Engineering Change Notice(ECN)

ECN-D-2608-04(Requirement for adding threaded holes)

FA Research ME 1 Team

Before(Problems and Change Requests)

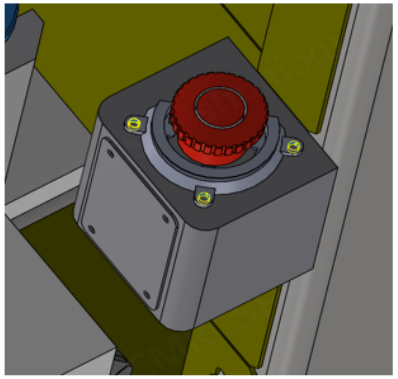
Our MFG department reported that there are no screw holes on the EMS button to secure the cover,requiring our MFG engineers to manually drill screw holes for each project.

After(Expected Effect)

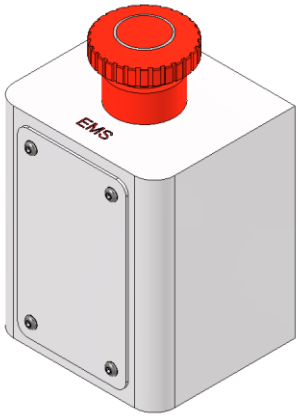
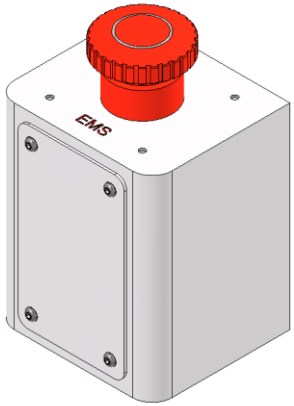
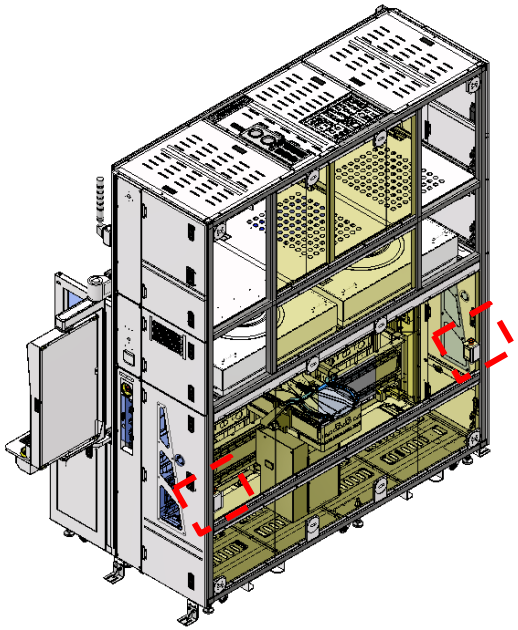
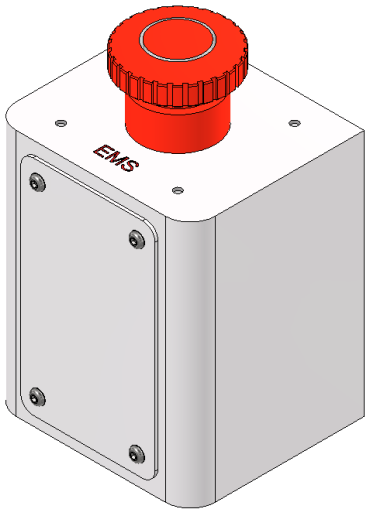
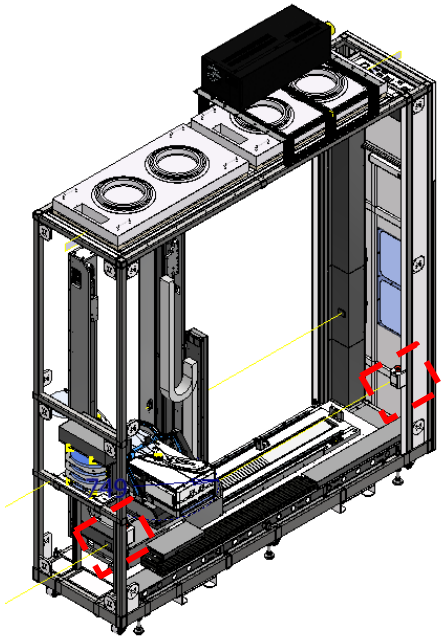
For subsequent EFEM and process robot,we would like to add three M3 threaded holes on the EMS button.Please refer to the figure below for the specific locations.

상세내용 Detail	- PN : DP-170P1-1(MIR)	- PN : DP-170P1-2(_MIR)
